NATIONAL CAPITAL DESIGN REVIEW PANEL

Block 16 Section 10 City
70 Allara Street

PROJECT BRIEF

Project: 70 Allara Street

Elevation – Building 2

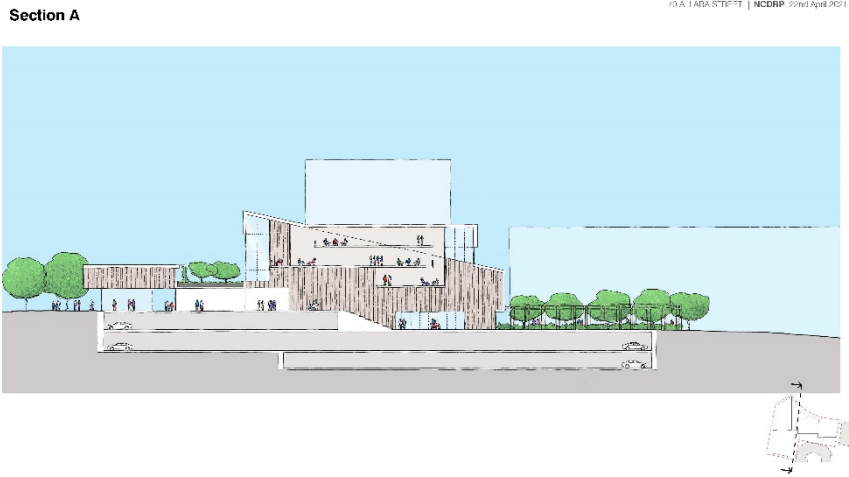
10.1 The Panel notes that the materiality of the proposal was not discussed in detail at the design review session however, the Panel considered the current extensive glazed façade presented to be incongruous with

BUILT FORM

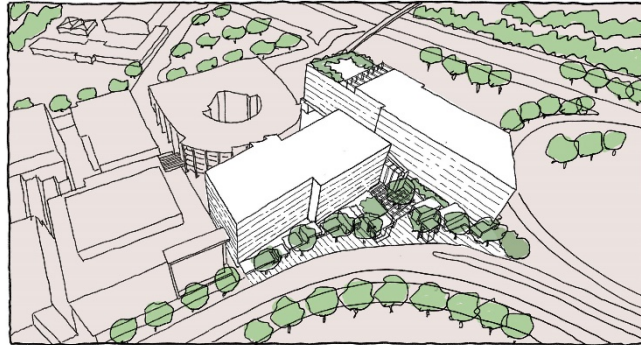
- 5.2 The Panel considers the scale of the commercial component currently proposed to be disproportionate and incompatible with the scale and built form of the proposed residential buildings when viewed from London Circuit. Overall, the Panel is unconvinced that the current proposal provides an appropriate outcome on this prestigious site. The proponent is strongly encouraged by the Panel to review the siting and design outcomes as well as articulation and modulation of built form to provide a better contribution to the city fabric and achieve stronger relationships between building forms both on site, and to adjacent and adjoining developments.

The commercial facility on Victoria Circle is an important element in the public welcome created by the development. The public realm is a focus of the London Circuit address, and leads through the development to Allara Street. The wings of the apartment buildings frame and shelter the courtyard at London Court, and provide a visual screen to the east of the major street.

BUILT FORM

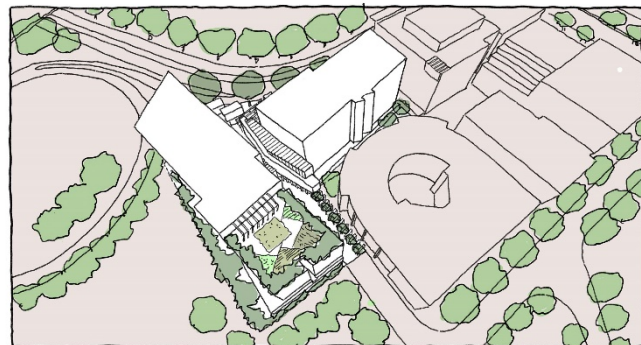
7.1 The Panel considers the location of the waste enclosure and service zones at the entry of the drop-off courtyard at Allara Street requires reconsideration to create a comfortable, active frontage and facilitate the creation of a safe environment for future users and pedestrians. Noting the size and extent of the proposed basement, the proponent is encouraged by the Panel to explore opportunities to embed these zones within the development to provide a more attractive shared space. The Panel also recommends consideration be given by the proponent towards opportunities to redistribute bulk and scale of the apartment building form away from the narrow entry to provide increased amenity.

The Allara Street address is a more compact proportion, with access from a single street. The proposed design increases the permeability represented by the public path through the site to the nearby river provided by creating an elevated passage through the development. Adjusting that public passage is an elevated, unobstructed central feature.
